Anvil Hill Coal Project

Independent Hearing and Assessment Panel

*Air Quality*

Figure 1: Model results based on 75% efficiency of haul road dust control (Source: Holmes Air Sciences)

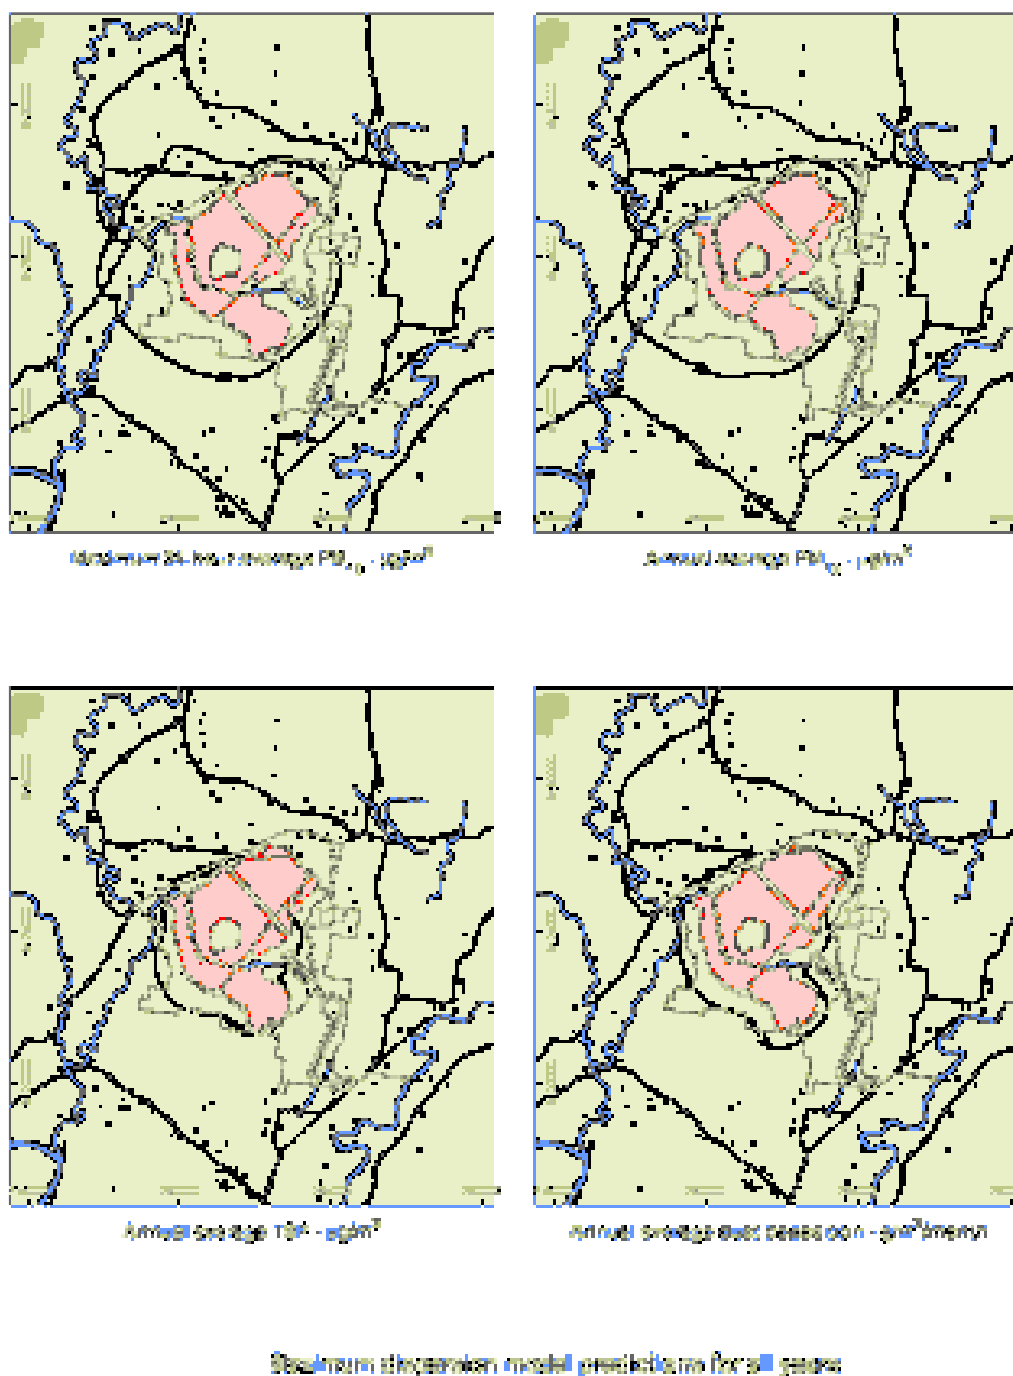
When considered in detail, these sources of potential underestimation are not individually large, but in combination are considered to be significant enough to not accept the assessment of the mine impacts as presented in the EA. Instead, I consider it more appropriate to rely on the modelling scenarios that are based on an assumed 75% efficiency of haul road dust control. Accordingly, the model results based on 75% control were supplied by Homes Air Sciences to enable an alternative assessment.

The assumption of 75% efficiency is probably pessimistic given the undertakings that have been made by the proponent with respect to dust control. It is reasonable to expect that actual performance will lie between 75% and 90%. However, by basing the assessment on the 75% control scenario, I consider that an adequate margin then exists to compensate for the other potential sources of underestimation indicated above.

Accordingly, the results generated by Holmes Air Sciences for the 75% haul road control scenario are presented below in Figure 1. Comparing this set of results to those presented in the EA Air Quality Assessment, a number of

additional residences appear in the impact zone at some time in the life of the mine. They are identified in Table 3.

The review has found that the impact of dust is likely to be somewhat greater than predicted in the Air Quality Assessment, and some additional properties have been identified as being potentially within the dust impact zone, mainly because of the influence of 24-hour PM<sub>10</sub> predictions. Of those additional properties, one is not on the current (January 2007) list of properties either owned by Centennial or under negotiation. Most/All of these additional properties are contained within the noise impact zone.

- It is recommended that after 12 months' operation of the mine, a dust model validation study be conducted. Should the validated model predict that properties other than those identified in the Air Quality Assessment and in this review will be adversely affected by mine dust, then the program of property acquisitions should be amended accordingly.
